Service Bulletin #SB026

Subject: Rear Grab Handle Reinforcement over Tandem of Trailer

SB026 - Rear Grab Handle Reinforcement

ORIG BY: DST	PROG. NO. —	MATERIAL —	MATERIAL DESCRIPTION —			
ORIG DATE: 10/14/2019	PROG. BY —	MAKE FROM —	PART YIELD —	SIMILAR TO —	SCALE 1:1	
CHK BY: —	PROG. DATE —	FINISH —	WEIGHT —	DWG. NO. —	SIZE A	
CHK DATE: —	TITLE KIT HAND RAIL REINF	PART NO. 161137		REV IR

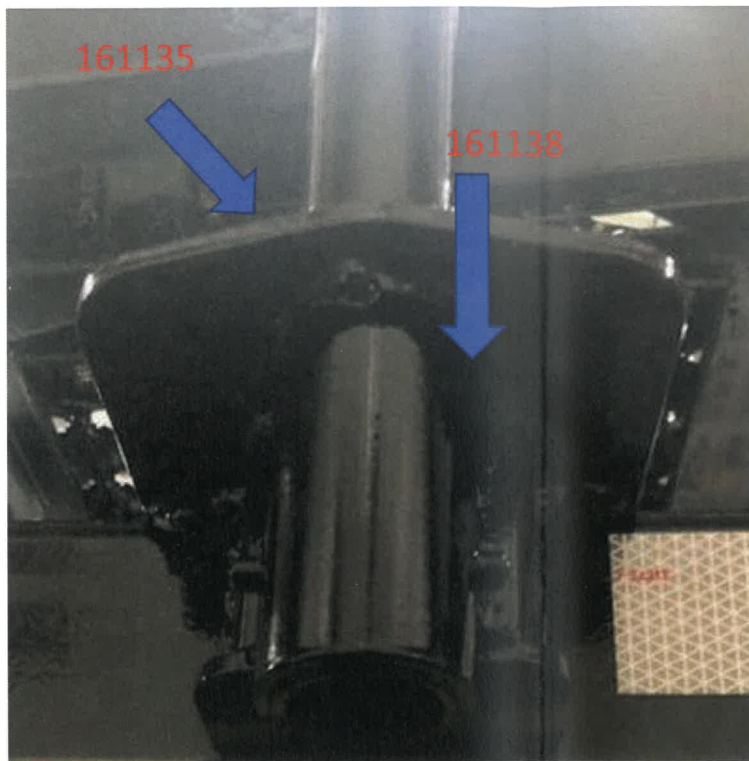
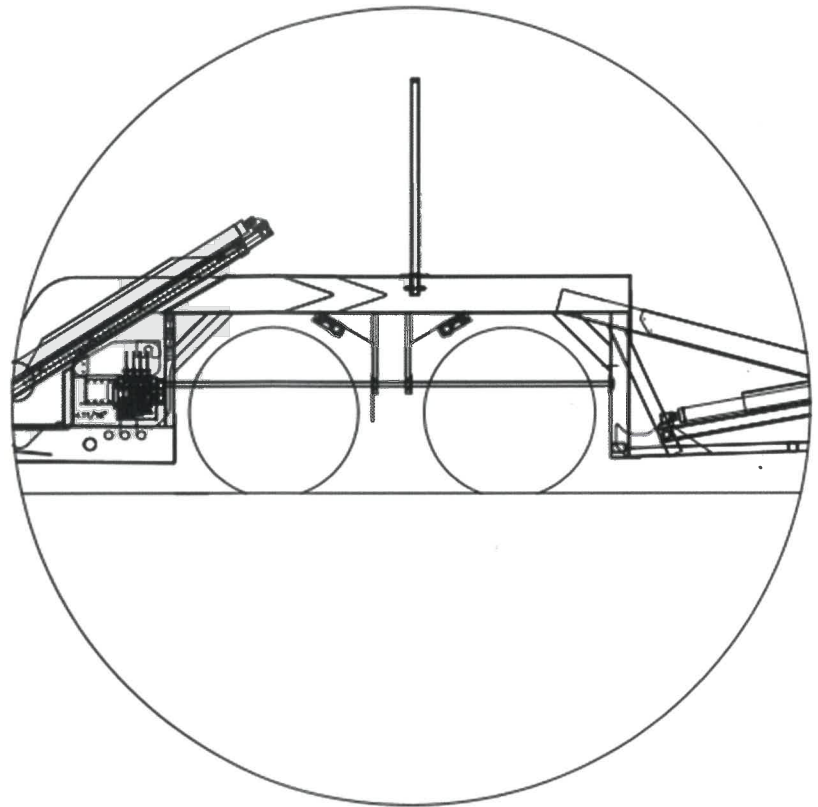
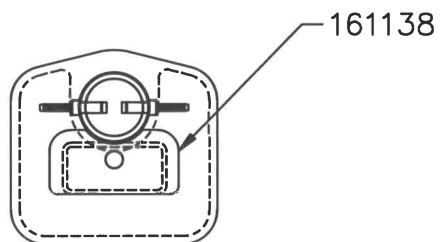
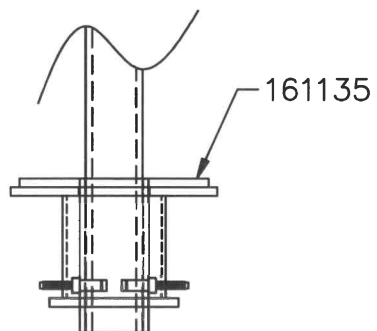
1. Identify units needing reinforcement kits per enclosed document with listed VIN's
2. Contact Cottrell with the VIN to have reinforcement kit shipped to a Cottrell Authorized Service facility or directly to you at no charge to you.
3. Schedule the unit for repairs at the Cottrell Service Center or any Cottrell Authorized Service facility.
4. Install rear reinforcement grab handle kit per attached drawing.

1. GOUGE OUT AND WELD UP CRACKS.
2. WELD PARTS AS SHOWN.
